UNITED STATES ENVIRONMENTAL PROTECTION AGENCY

Re: Rocky Mountain Arsenal (RMA)
Integrated Endangerment
Assessment (IEA)

We have reviewed the Proposed Final Integrated Endangerment Assessment. As provided by the Federal Facility Agreement (FFA), Section 30, we invoke or continue dispute on the issues outlined in the enclosure.

Dieldrin in Surficial Soils (ppm)

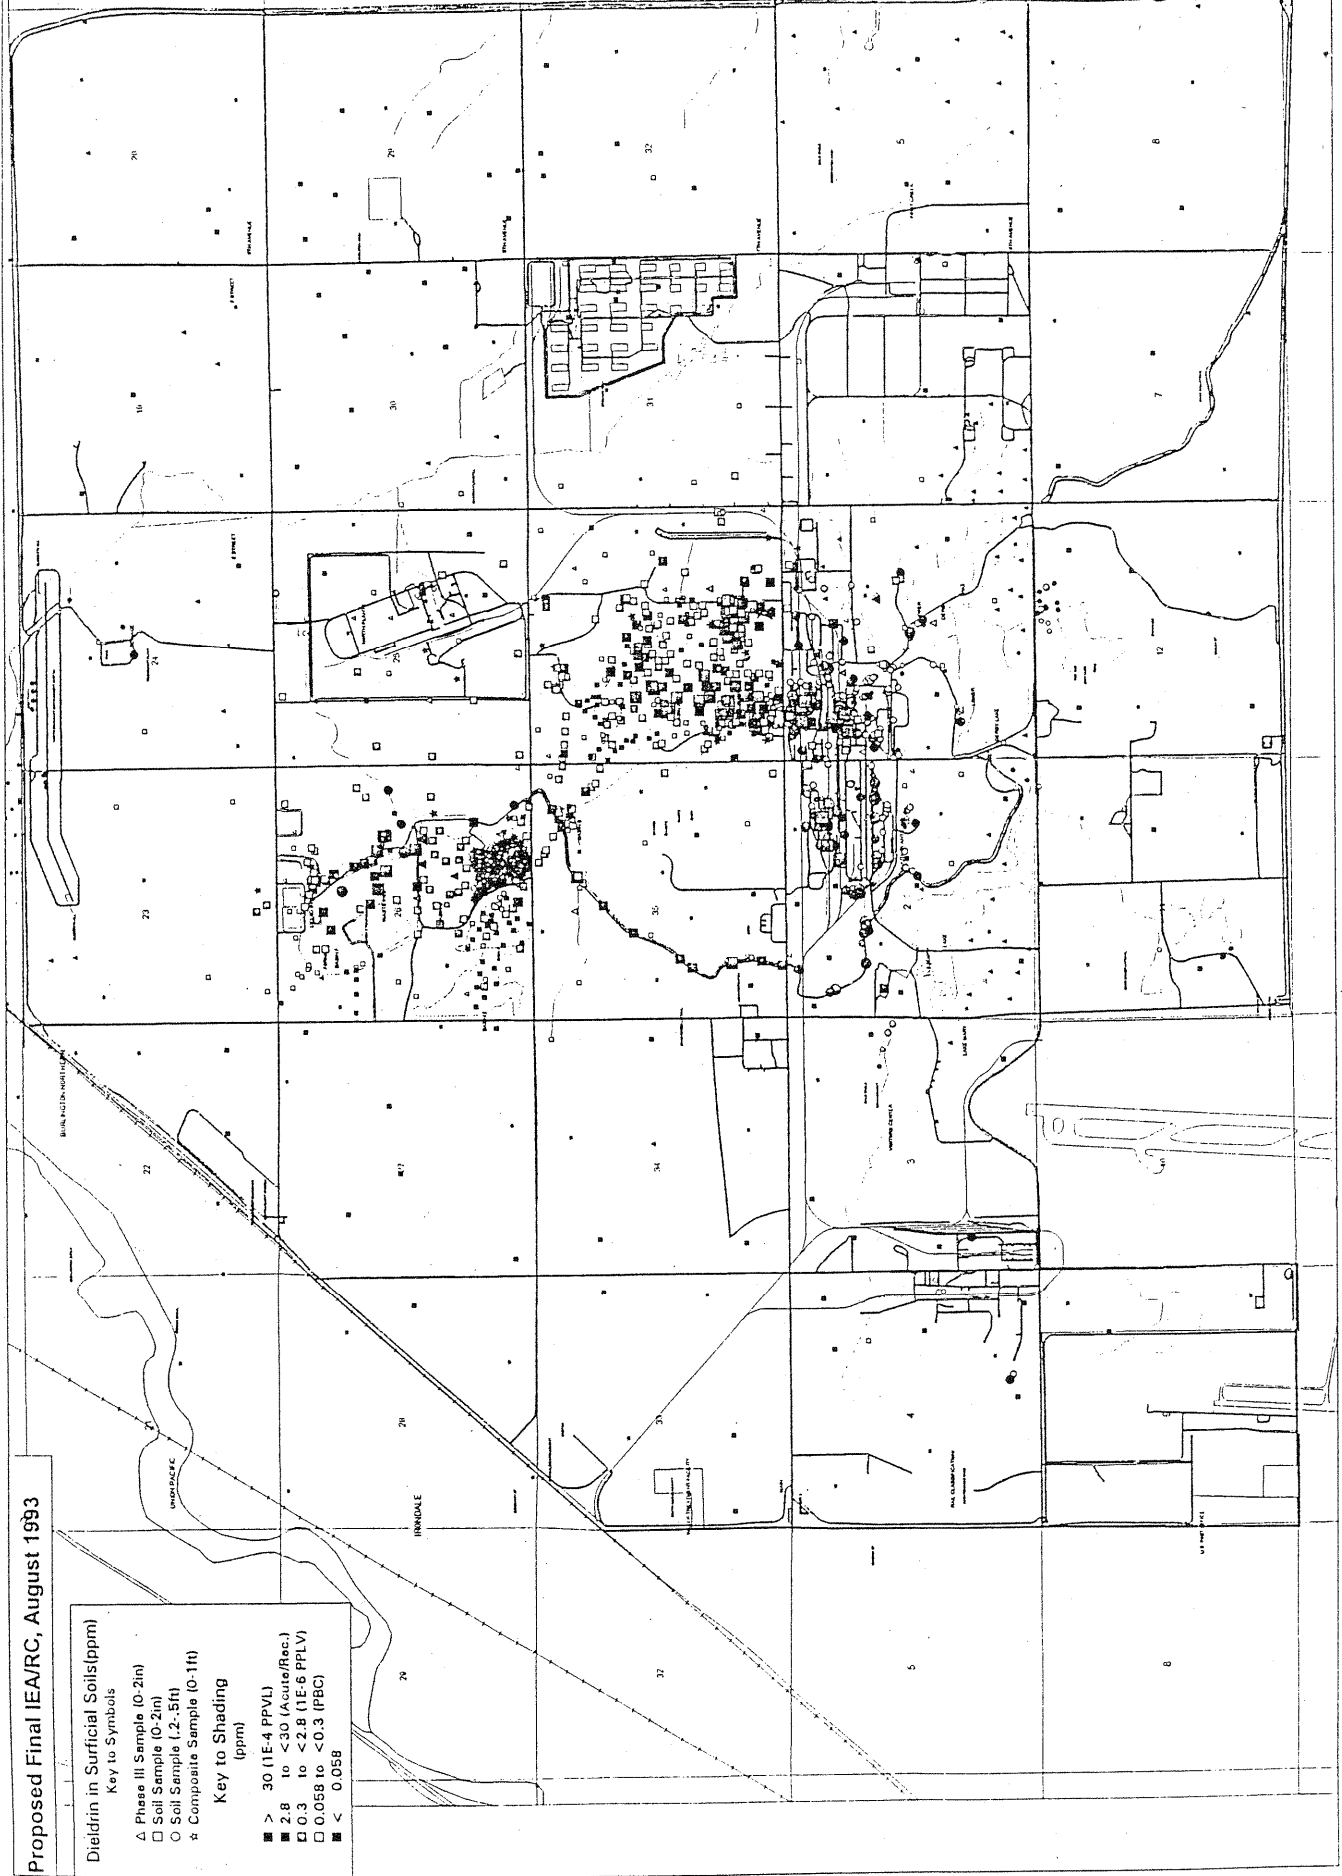
As indicated in our letters of December 7, 1992, May 20, and July 20, 1993, the Army was to recalculate and present the revised PPLVs for aldrin and dieldrin for all human exposure scenarios. We also recommended presentation in the IEA of a map outlining the areas at RMA that exceed acute levels for these chemicals, similar to the attached map, provided by CDH.
